Access Compliance Report

(Curb Ramps)

Intersection ID: 16194	Main Street: FERN_GLEN_CT	Cross Street: SPLIT_OAK_DR	Location: NE
ADA ID: 3EED38895DDF	Ramp Type: PerpDiag	Initial Pass/Fail: Fail	Overall Compliance: No
Severity Score: 50			
Codes/Mitigation Info/Possible Solution		Field Measurements/Component Compliance

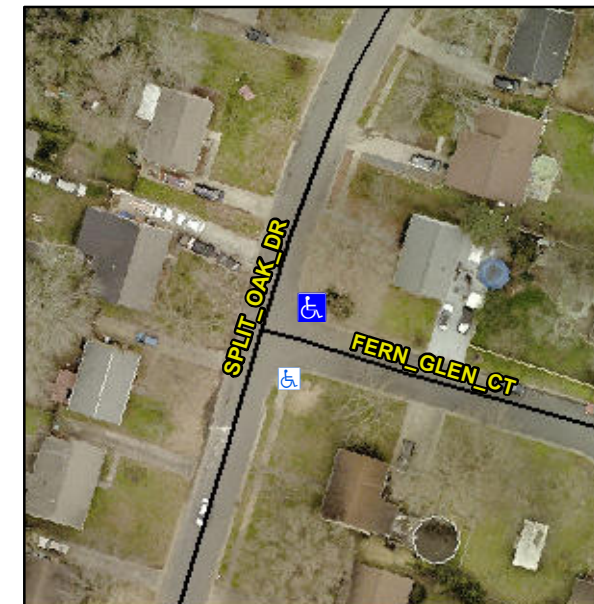
Not Found, R304.2.2, R304.5.3

Compliance	Description	Data	Compliance	Description	Data
N/A	Ramp Length (in)	93.0	No	Ramp Slope (%)	14.2
Yes	Ramp Width (in)	48.0	No	Ramp XSlope (%)	11.0
N/A	Flare Type LT	N/A	N/A	Flare Type RT	N/A
N/A	Flare Slope LT (%)	N/A	N/A	Flare Slope RT (%)	N/A
N/A	Flare Traversable LT?	N/A	N/A	Flare Traversable RT?	N/A
N/A	Landing Length (in)	N/A	N/A	DWS Provided?	N/A
N/A	Landing Width (in)	N/A	N/A	DWS Contrast?	N/A
N/A	Landing Slope (%)	N/A	N/A	DWS Length (in)	N/A
N/A	Landing X Slope (%)	N/A	N/A	DWS Full Width?	N/A
N/A	Landing Curb? (Y/N)	N/A	N/A	DWS Offset (in)	N/A
N/A	Shared Landing?	N/A			
N/A	Gutter Ponding?	N/A	N/A	Gutter Slope (%)	N/A
N/A	Gutter Lip Ht (in)	N/A	N/A	Gutter X Slope (%)	N/A
N/A	Painted X Walk1?	No	N/A	Painted X Walk2?	No
	X Walk 1 Direction	To NW		X Walk 2 Direction	To SW
N/A	X Walk 1 Width (in)	N/A	N/A	X Walk 2 Width (in)	N/A
	X Walk 1 Slope (%)	8.0		X Walk 2 Slope (%)	1.1
	X Walk 1 X Slope (%)	0.4		X Walk 2 X Slope (%)	7.3

Remove & Replace Curb Ramp With Two New Directional Ramps or Equivalent.
